**BID**  
**ADDENDUM NO. 1**  
**TO**  
**CONTRACT DOCUMENTS**  
**AND**  
**TECHNICAL SPECIFICATIONS**  
**FOR**  
**2019 BOND REFERENDUM**  
**CAPITAL IMPROVEMENTS**  
**AT**  
**CHATSWORTH AVENUE SCHOOL**  
**NYSED #66-07-01-03-0-005-020**  
**BID # 19/20-MUFSD-010**

Mamaroneck Union Free School District  
1000 West Boston Post Road  
Mamaroneck, New York 10543

**LAN Job #4.1092.72.03**  
December 22, 2020

## A7.30

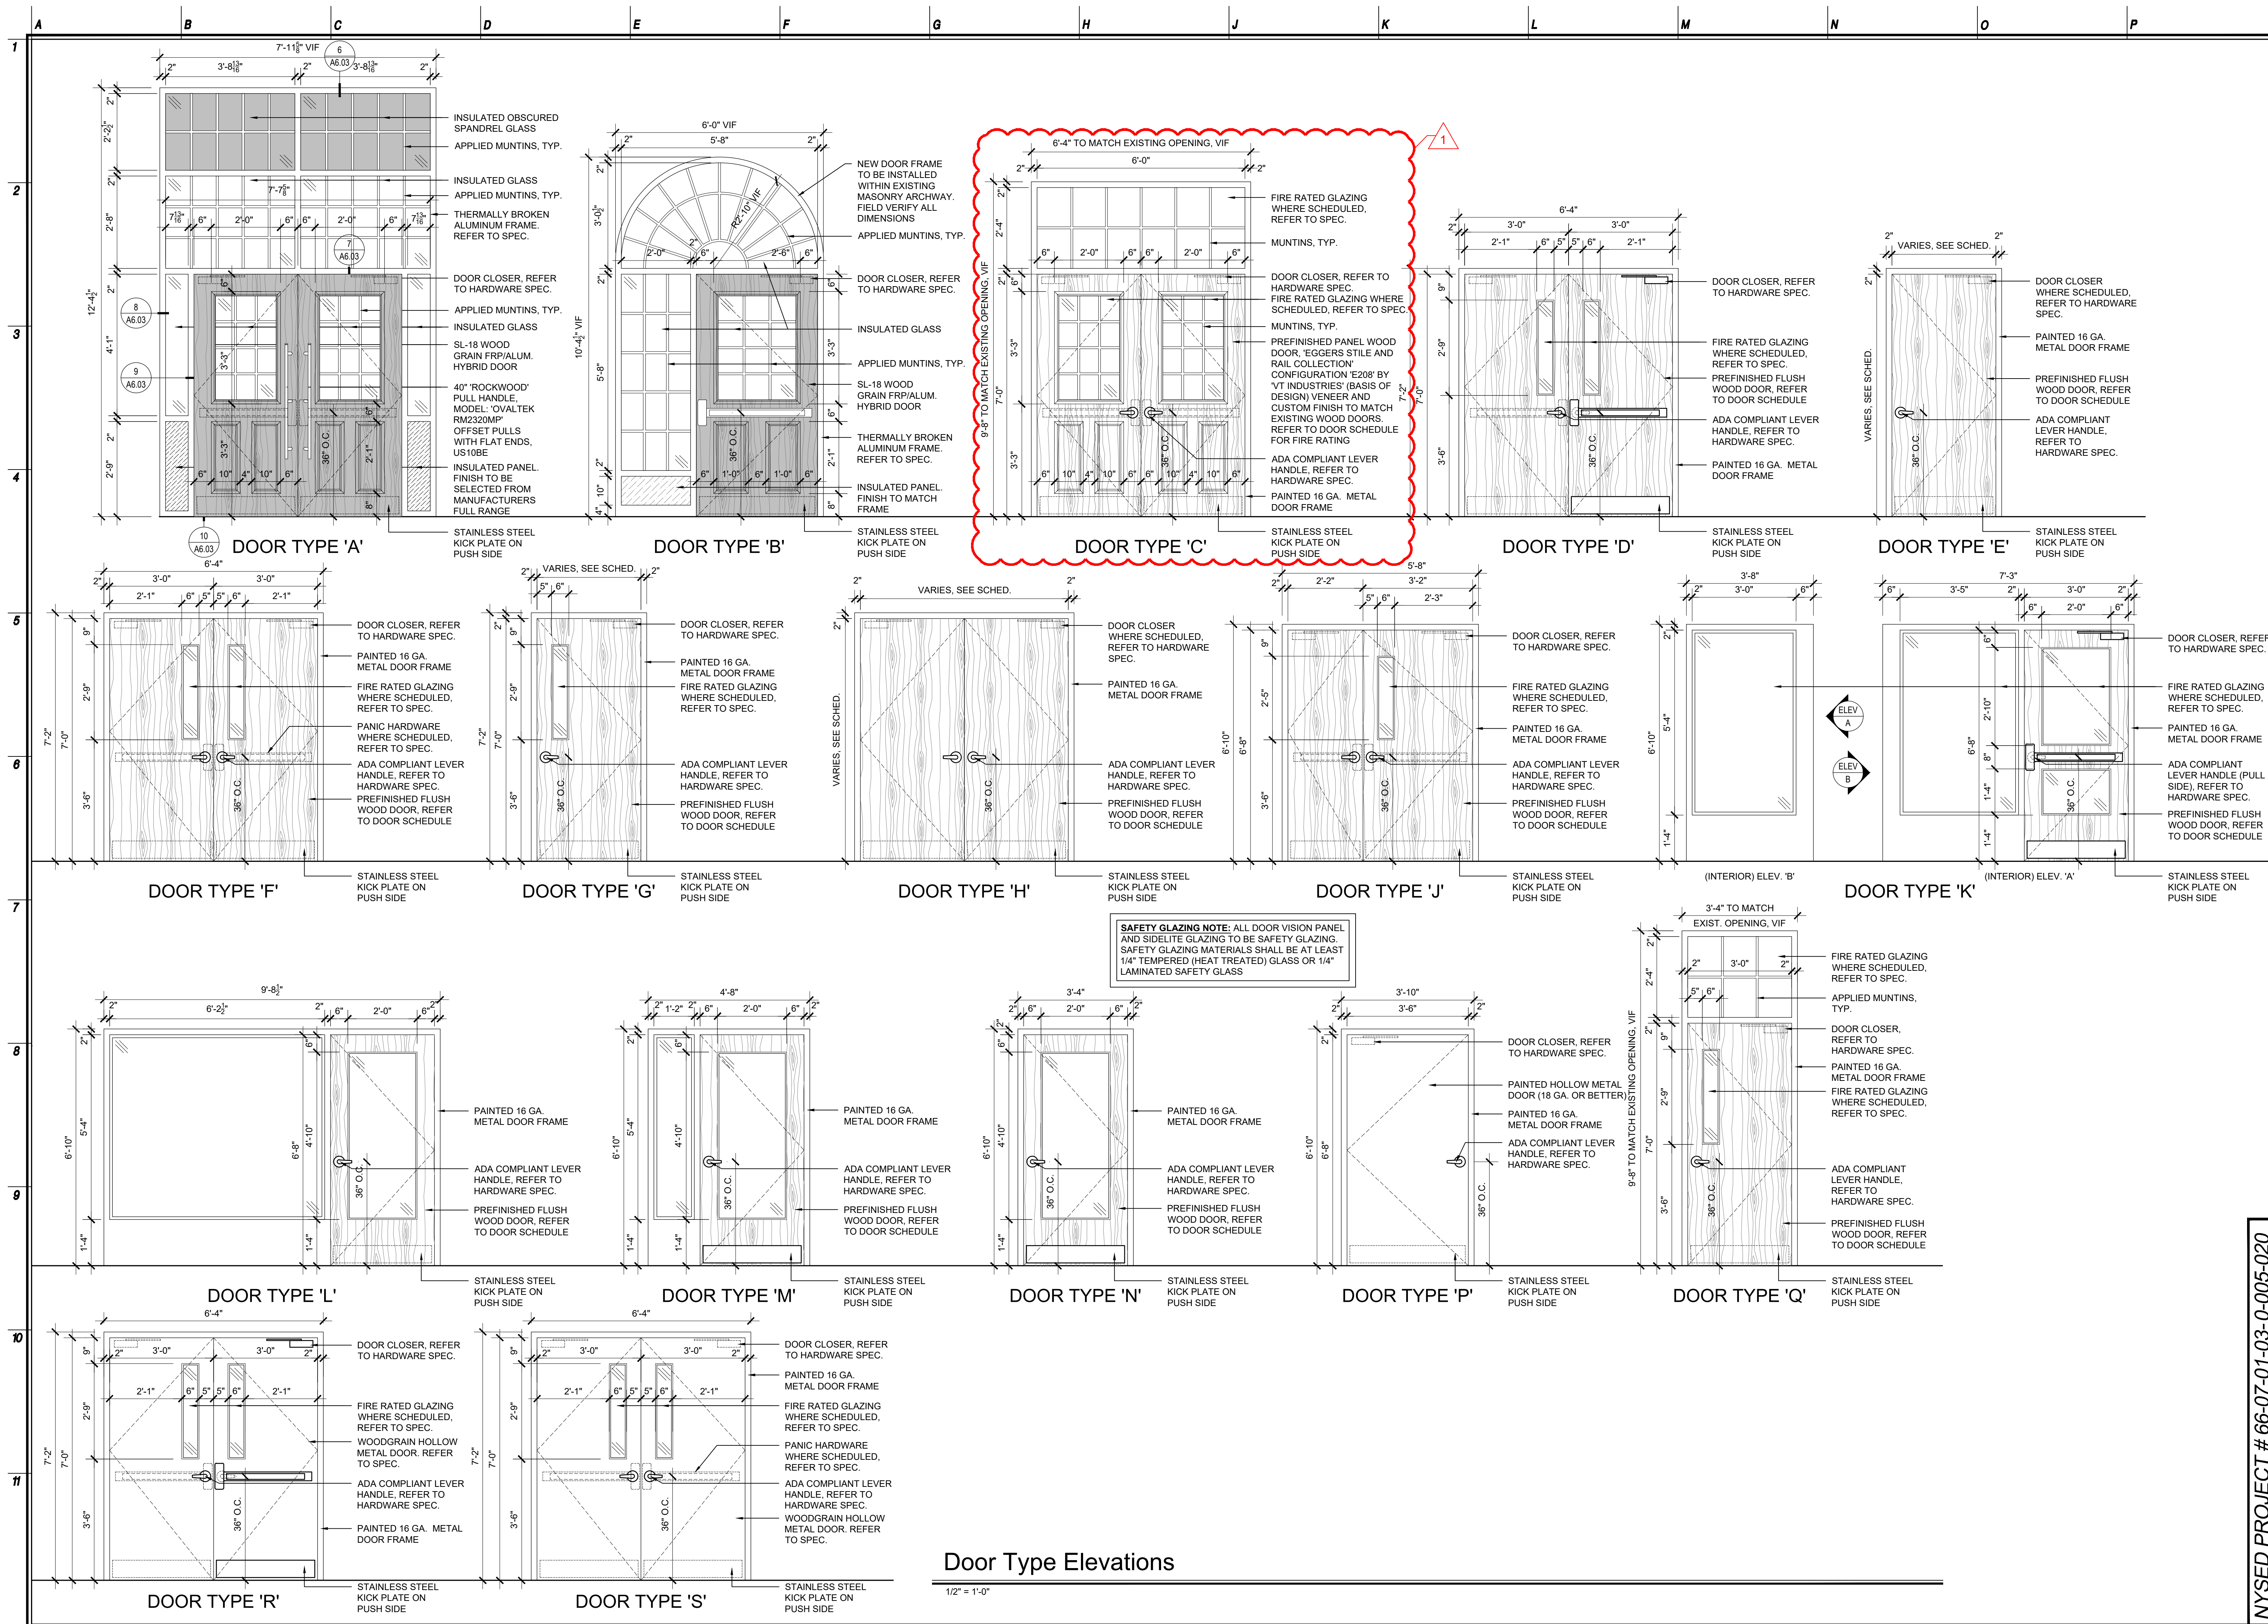
Drawing No.	Addendum Requirements
H1.02	Drawing H1.02 has been removed from the set as no Asbestos work remains on this drawing.  Room 309 Floor Tile & Mastic Abatement has been deducted from the scope of work (Abated November 2020).
A2.00	Construction Key Notes for Work Areas “B” and “C” have been updated per clarifications and questions listed below in section 4.0.
A6.02	Door Type “C” has been updated to specify the basis of design panel wood door series.
A7.30	Construction Key note D15 has been revised.

Response:	Loose furniture will be removed by Owner.
4	Question:	Is the quarry tile in the existing Kitchen to be removed?
	Response:	Yes, Quarry tile demolition is shown on A1.10 demolition key note "36" with shaded area. Self leveler is called out with shaded area as key note "B30" on sheet A2.10.
5	Question:	If the Add Alternate for the Sky Gym on A7.30 is not taken, is there any work that needs to take place in the Sky Gym?

Response:	Yes, please refer to the boxed area of interior elevation 2/A7.30 indicating work that is to be part of the base bid.
6	Question:	The notes on A2.00 state that the casework countertops are to be plastic laminate but specification section 123554 – Manufactured Casework states that it is solid surface.
